APPLICANT: Patricia J. Hunt **PETITION NO.:** V-54
PHONE: 770-434-3354 **DATE OF HEARING:** 06-11-08
REPRESENTATIVE: same **PRESENT ZONING:** R-20
PHONE: same **LAND LOT(S):** 305, 306
PROPERTY LOCATION: Located on the north side of **DISTRICT:** 17
Floyd Street, west of Hall Drive **SIZE OF TRACT:** .271 acre
(403 Floyd Drive). **COMMISSION DISTRICT:** 4

TYPE OF VARIANCE: 1) Waive the side setback on lot 13 from the required 10 feet to 5 feet adjacent to the western property line; 2) Waive the side setback on lot 13 from the required 10 feet to 9.6 feet adjacent to the eastern property line; and 3) Waive the front setback from the required 35 feet to 34 feet.

Application for Variance Cobb County

Application No. V-54
Hearing Date: 6-1-08

V-54
(2008)

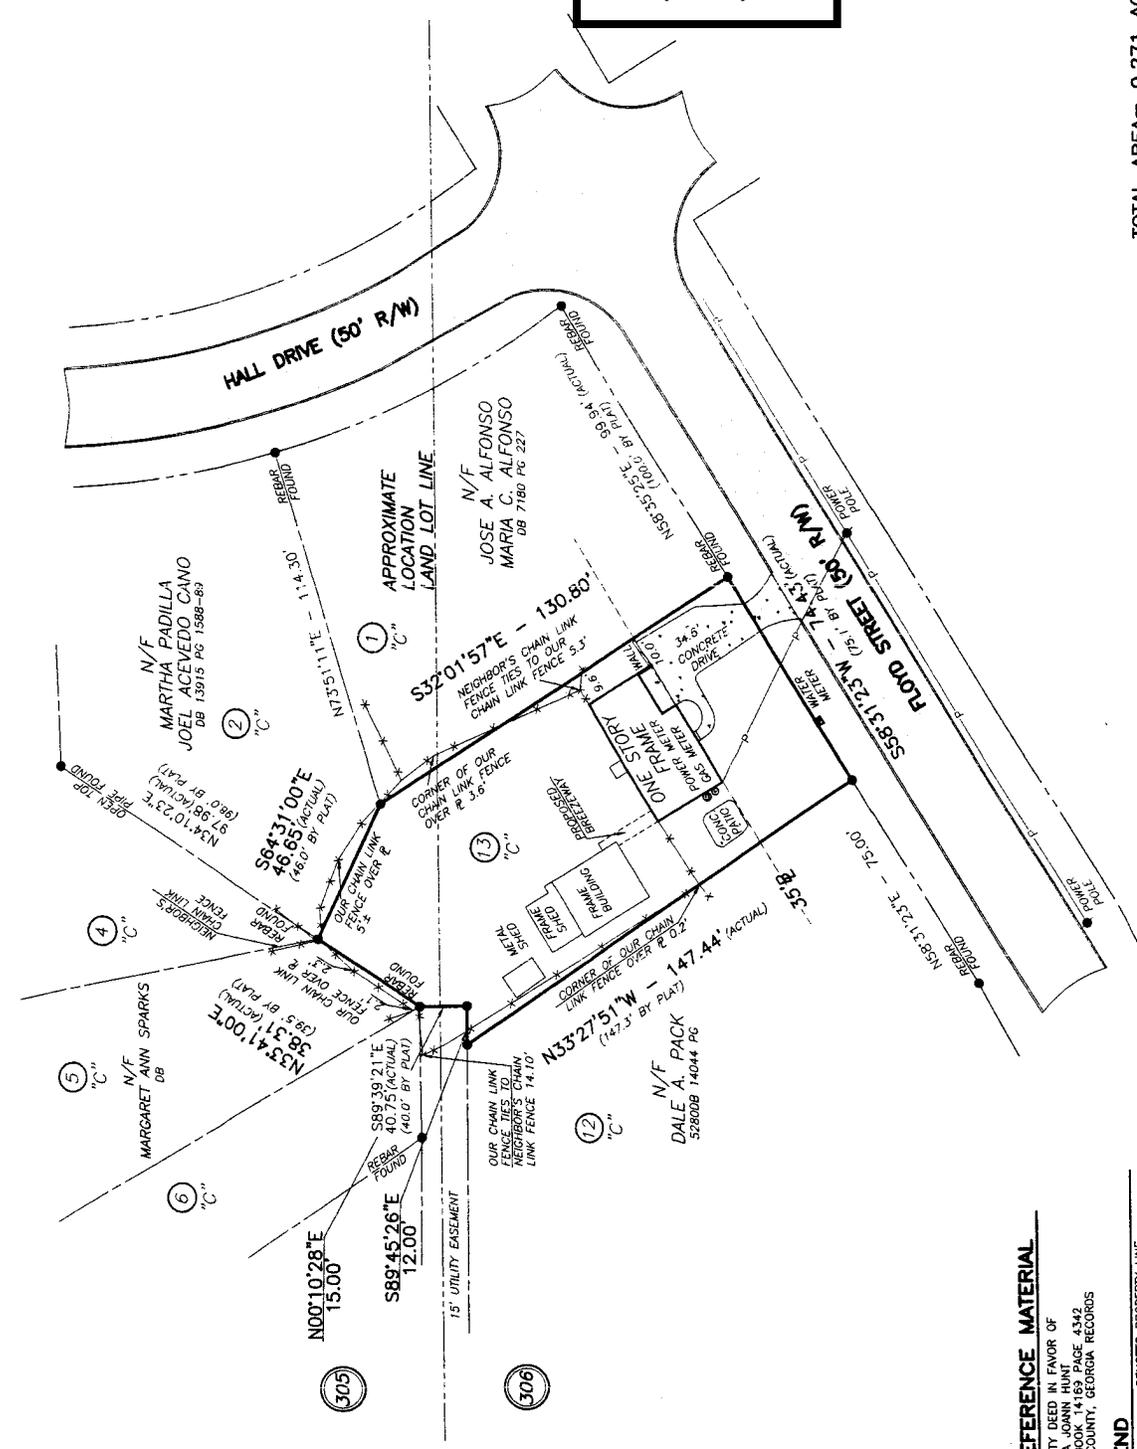
TRAFFIC: This request will not have an adverse impact on traffic.
DEVELOPMENT & INSPECTIONS: Structure is existing. Permits required for any approvals of variance prior to construction of the breezeway. Existing structure will need to be inspected prior to occupancy. If this variance request is approved, a plat revision must be recorded reflecting the conditions of the variance. The surveyor must submit the revised subdivision plat to the Site Plan Review Section, Community Development Agency for review and approval prior to recording. Call 770-528-2147.
STORMWATER MANAGEMENT: There does not appear to be any negative stormwater management impacts associated with this structure. However, it does not look suitable for living space since the only entry is a single side door and a garage roll-up door. There does not appear to be any windows on the structure.
HISTORIC PRESERVATION: After examining Civil War trench maps, Cobb County historic property surveys, county maps, and various other resources, staff has no comments regarding the impact or treatment of historic and/or archaeological resources.
